REMEDIAL ACTION
CONSTRUCTION COMPLETION
REPORT

VOLUME II
AS-BUILT DRAWINGS
& DESIGN CHANGE FORMS

Pine Street Canal Superfund Site
Burlington, Vermont

DESIGN CHANGE FORMS

**DESIGN CHANGE #5: EXTENSION OF RIPRAP
APRON AT B.E.D. STORMWATER OUTLET
PINE STREET CANAL SITE, BURLINGTON, VT.**

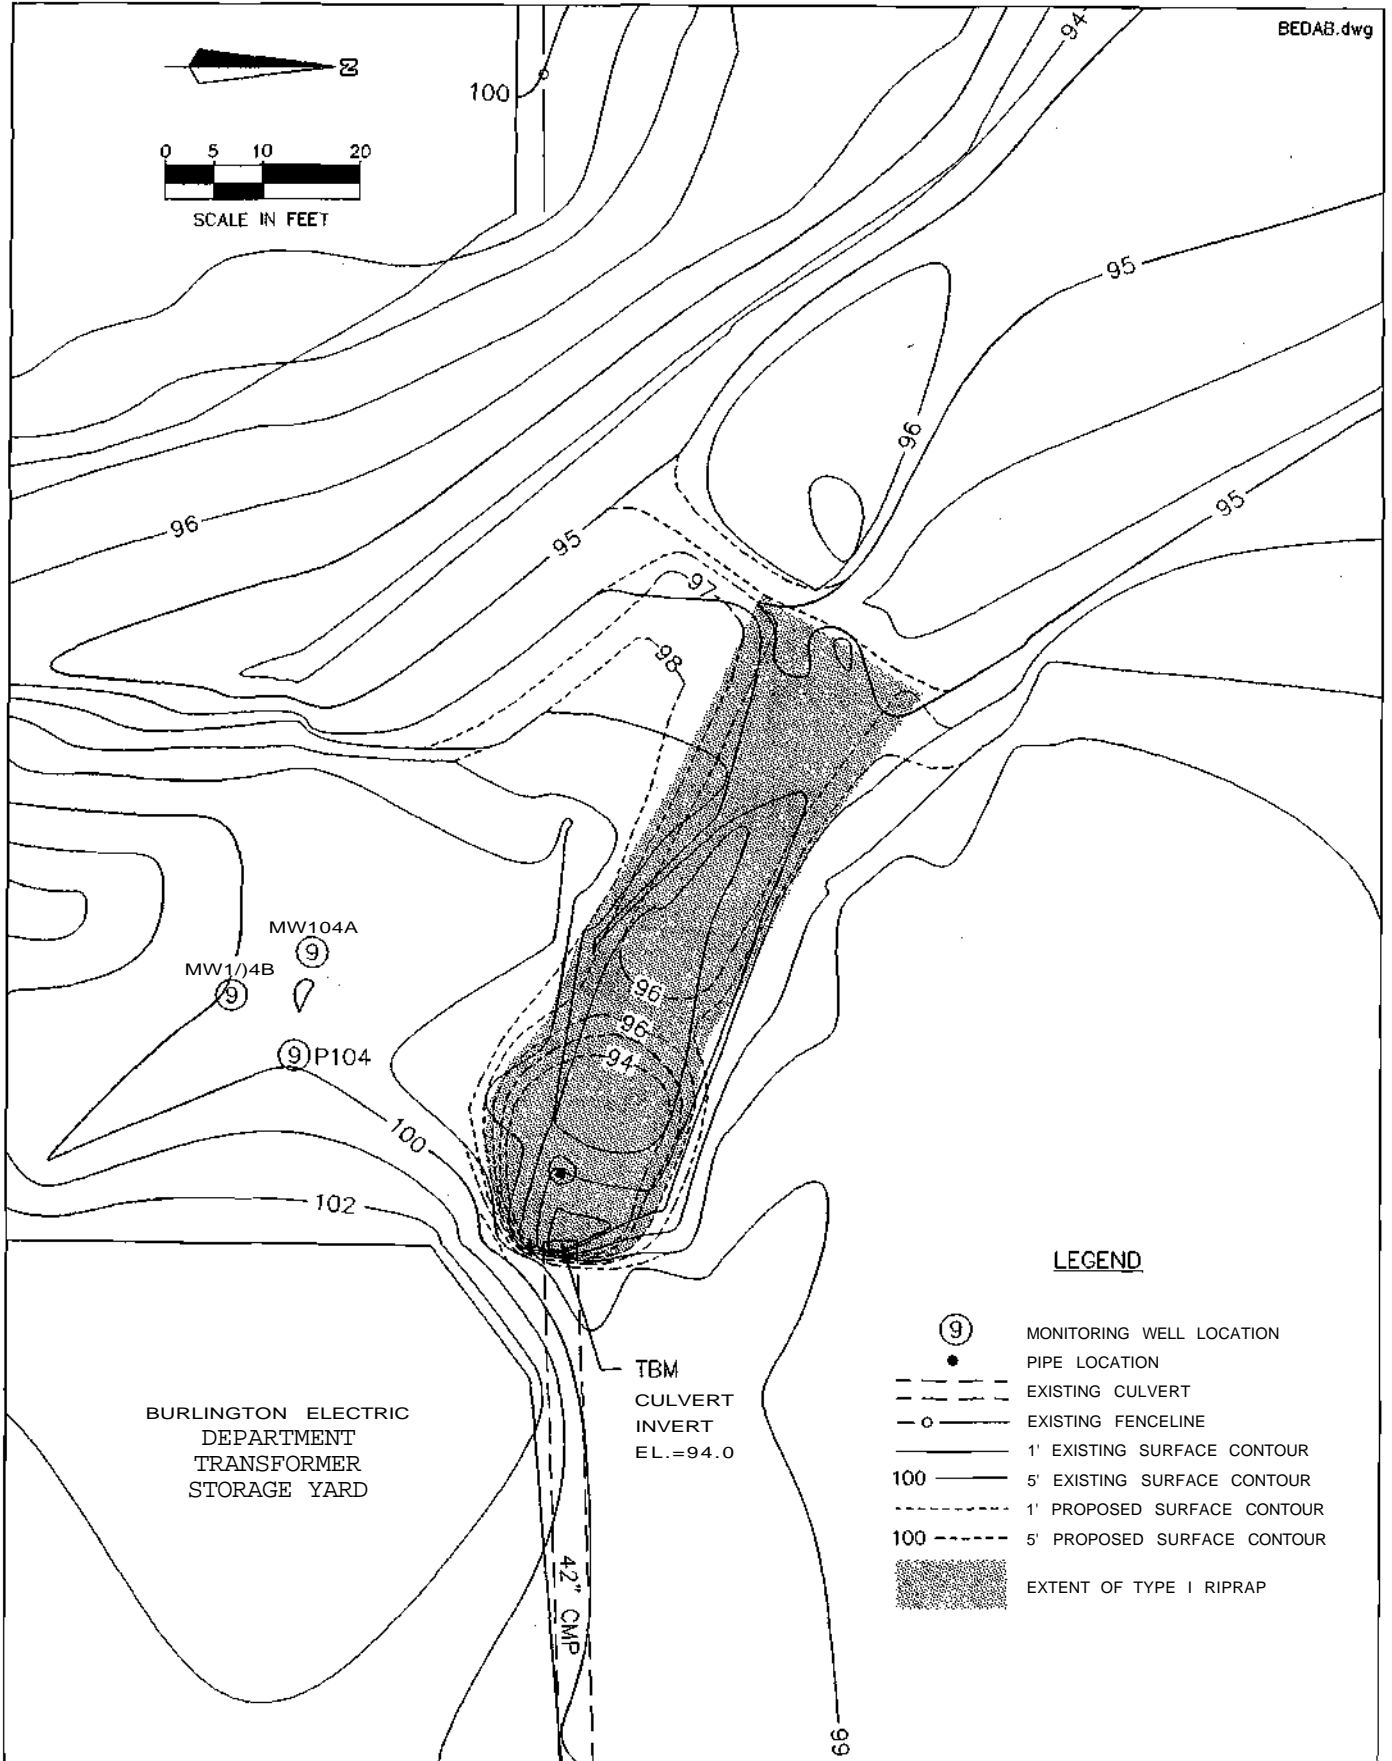
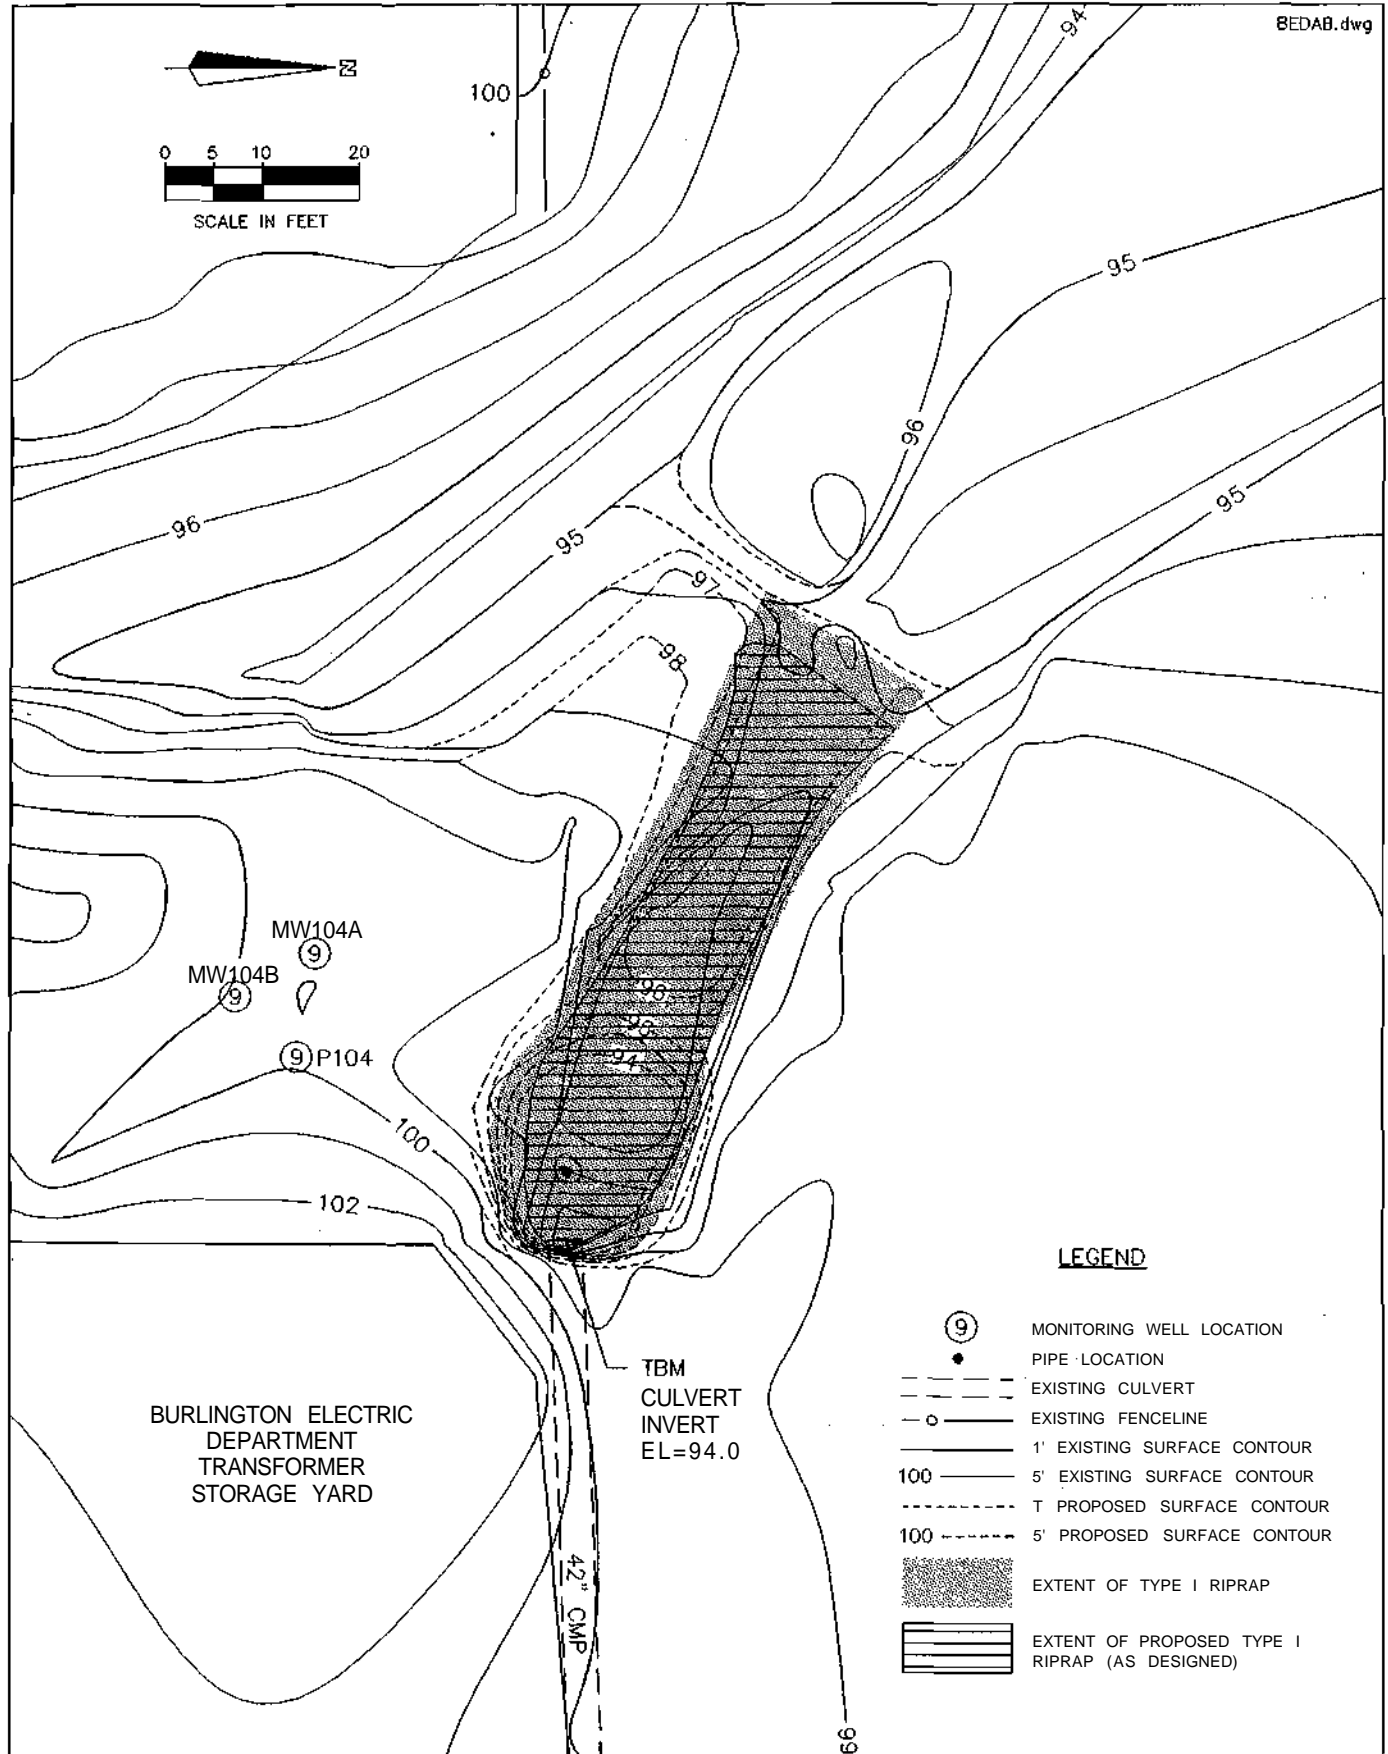
Notification of a Field Change in the geometry of the BED outfall plunge pool apron was provided to de maximus in a single page summary dated August 21,2002. The rip-rap apron geometry needed to be changed due to changes in the existing ground surface topography since 1994, when the area was last surveyed.

Specifically, additional sand and sediments had been naturally deposited at the proposed end of the apron, raising the ground surface elevation by more than a foot since 1994. In order to provide a smooth transition between the rip-rap apron and the existing ground surface it was necessary to extend the apron by six feet in a down-gradient direction, and to reduce the slope of the apron surface. It was also necessary to slightly increase the width of the apron in order to maintain the bottom width and side slopes at designed.

These changes will not decrease the sediment removal efficiency of the apron and plunge pool from that in the approved design (see Sheet 8 of 8 - Grading Plans and Details, B.E-D. Stormwater Outlet). Actually, the sediment removal efficiency is likely to be increased by the decreased slope and increased length of the rip-rap apron.

These changes will not reduce the storm-water carrying capacity of the BED culvert from that in the approved design. During design, the BED pipe capacity was calculated for a cross-section across the plunge pool outlet sill (at 96 ft NGVD). This sill is not affected by the proposed design change, and is the primary control for stormwater flow from the BED culvert.

The proposed changes will not significantly affect the wetlands area at the Site. Approximately 0.003 additional acres of rip-rap will be added by the proposed design change.

**WATERWAY DESIGN CHANGE #6
AREA 3/2 GRADING PLAN
PINE STREET CANAL SITE, BURLINGTON, VT**

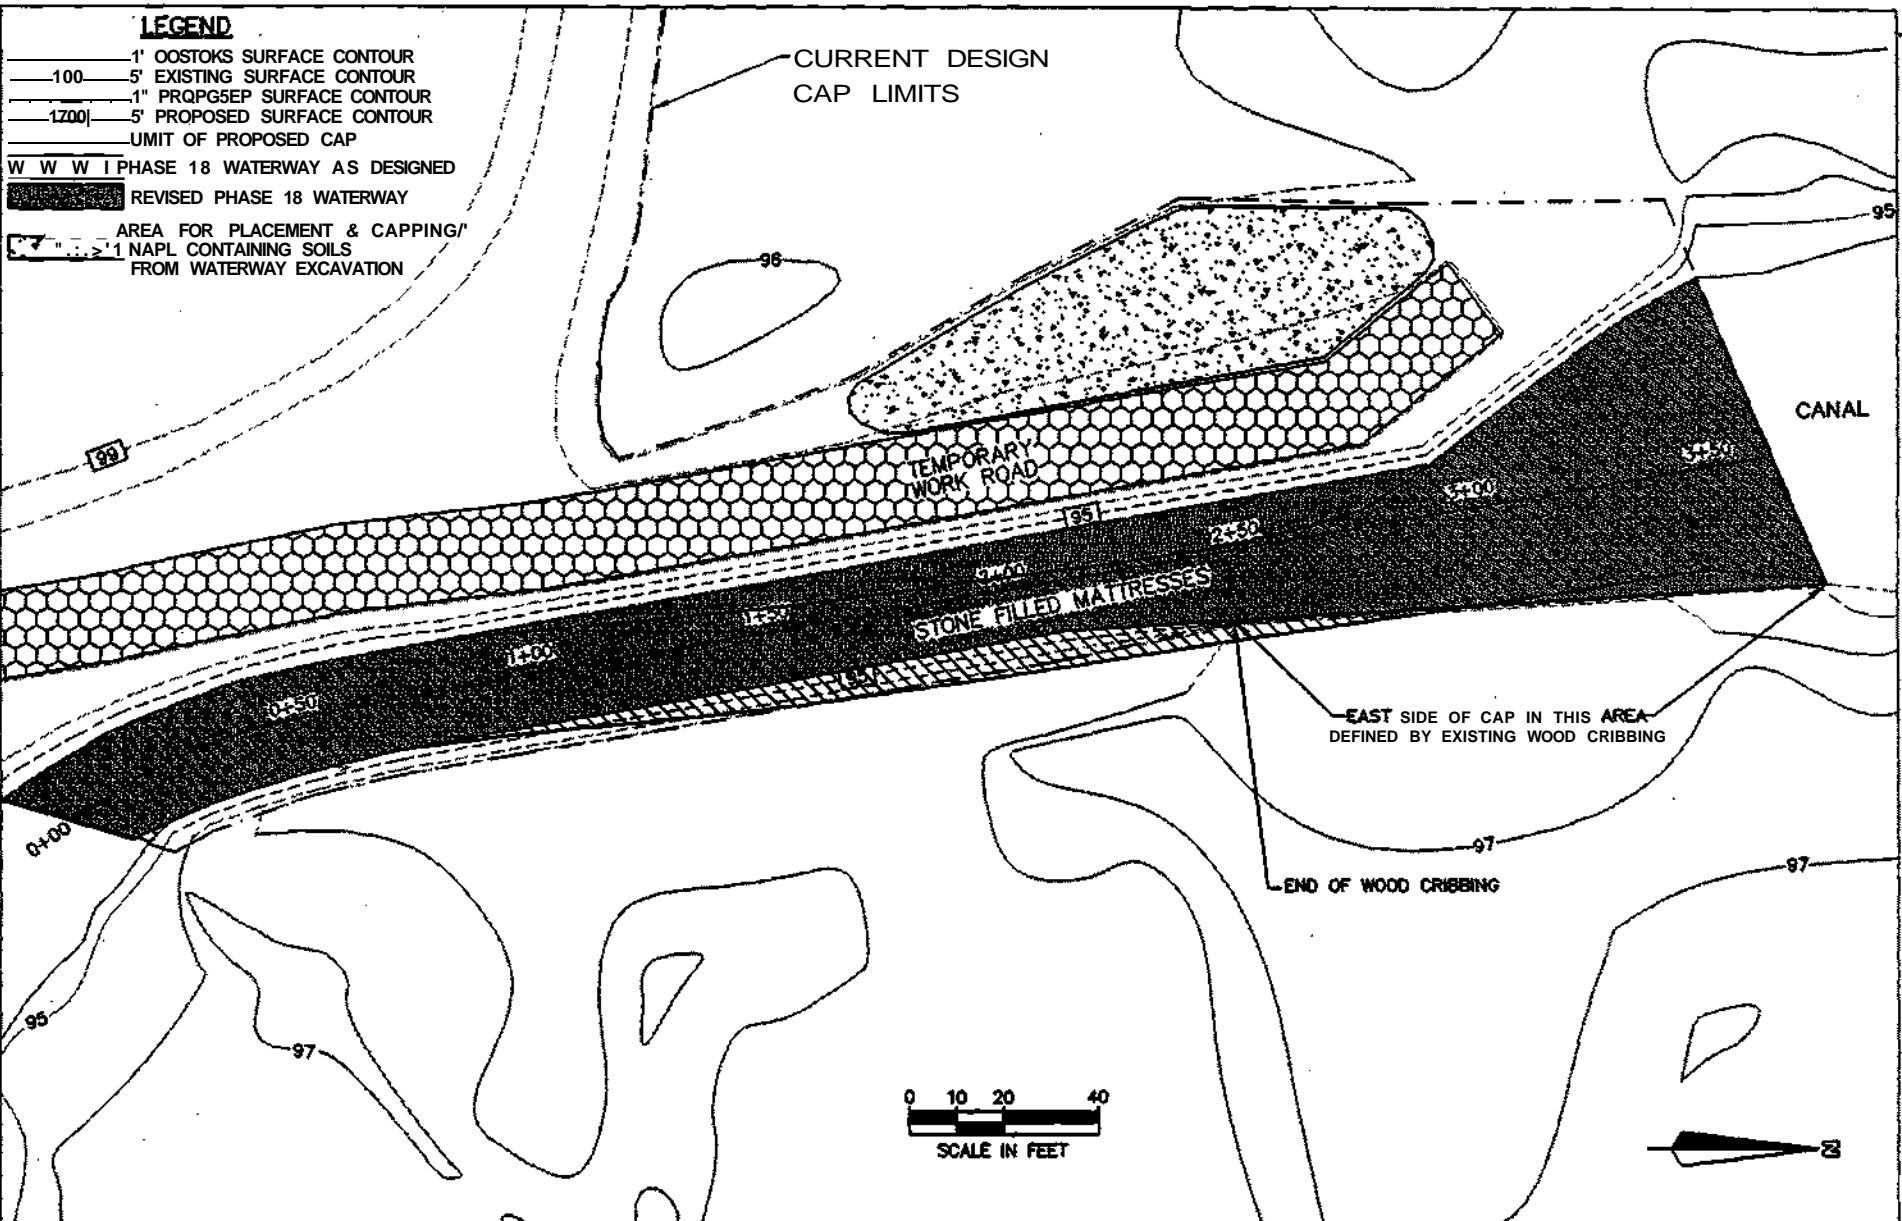
The proposed design change is to shift the centerline westward approximately 10 feet at Station 2+15 and re-align the waterway to match the cribbing alignment (see attached *Waterway Design Change #6, Area 3/2 Grading Plan*). The coir logs used to define the edges of the waterway will extend up to and alongside the cribbing. This is a simple re-alignment of the waterway to meet the field conditions (keep the waterway between the cribbing).

The width of the waterway will be unchanged. The location of the temporary work road will have to be shifted slightly west to accommodate the waterway, which will casue the capped portion of Area 2 west of the work road to be slightly reduced in area. There are no expected adverse consequences to this proposed change.

It is proposed that soils with visual evidence of NAPL (e.g. with flowable or blobs of product) will be placed and capped on the west side of the temporary access road in Area 2 (please refer to the stippled area on the attached *Waterway Design Change #6, Area 3/2 Grading Plan* for the specific proposed location). The proposal is to move them from one side of the road to a controlled area on the other side. Since the entire area will be capped and the contamination appears to be present at similar depths in Area 2, the inclusion of these minor quantities of NAPL containing soils will not effect the overall performance of the cap.

The stippled area on the attached grading plan will accommodate the expected volume of materials with no expected change to the approved grading plan contours if they are placed at a thickness of approximately 0.3 feet and covered with the approved 1.5 foot cap design. The current ground surface elevation in this area is approximately 94.5 ft NGVD, the approved final grade is between 96 and 97 ft NGVD.

DESIGN CHANGE #6
 AREA 3/2 WATERWAY PROFILES
 PINE STREET CANAL SITE, BURLINGTON, VT

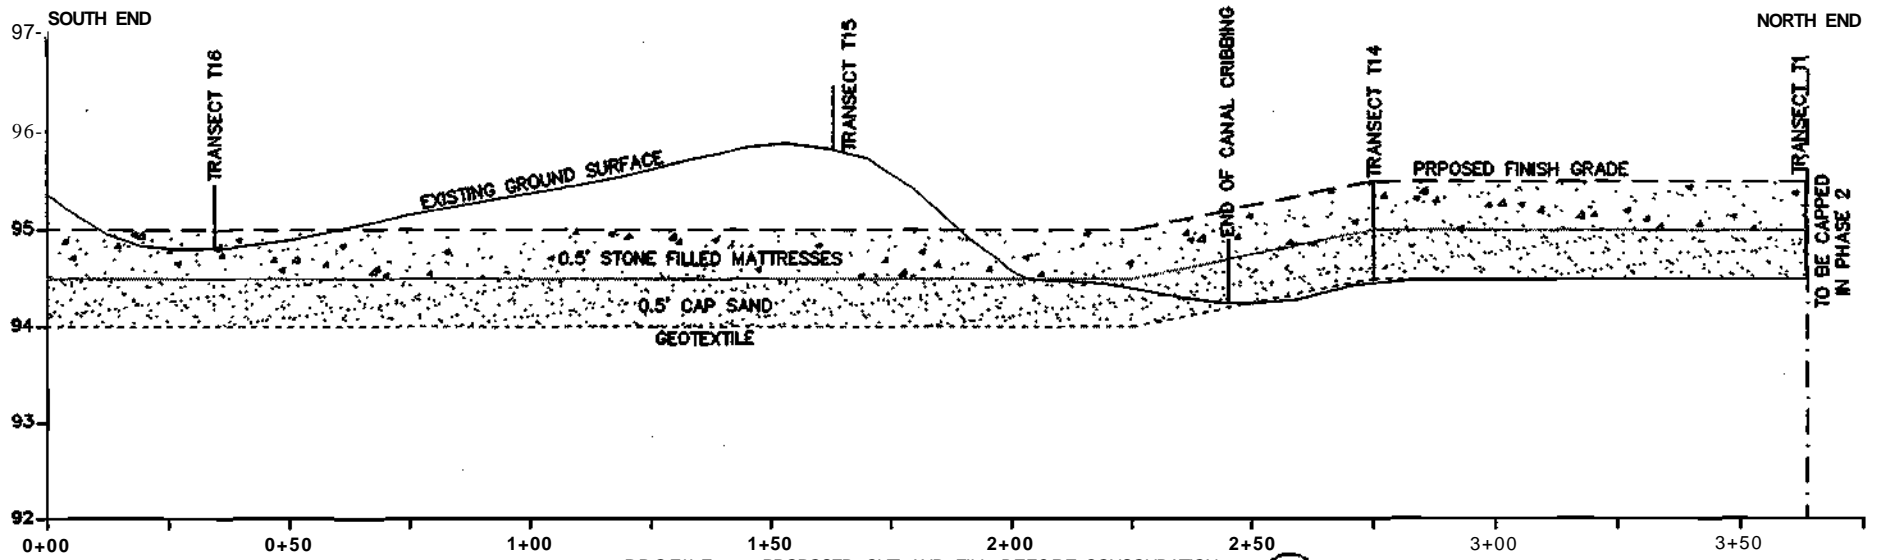
During the layout of the waterway, it was determined that the existing grades at the south end of the waterway had increased about a foot since last surveyed. At the south end of the waterway, the current grades range from elevation 94.9 to 96.3 ft NGVD, as compared with elevations between approximately 93 and 95.3 ft NGVD shown on Sheet 5 of 8 of the approved Design Drawings.

The proposed change is to raise the waterway finished grade before settlement to 95 ft NGVD in order to approximately meet the average existing grade south of the waterway. The north end of the waterway is proposed to be placed on the existing grade with a finished grade at approximately 95.5 (before settlement). This finished grade at the north end will later transition into the Phase 2 cap which will also be placed at the existing grade (elevation 94.5) at the south end of the Phase 2 work. The existing and proposed grades for the waterway are shown on the attached *Design Change #6, Area 3/2 Waterway Profile*.

As shown on the attached Grading Plan and Profile, Station 2+50 marks the approximate southern extent of where the Canal was formerly dredged. The proposed design change limits the excavation for the waterway to a subgrade cut to 94 ft NGVD between Stations 0+00 and 2+50 (plus or minus 25 feet north/south) and eliminates excavation north of Station 2+50 (plus or minus 25 feet north/south).
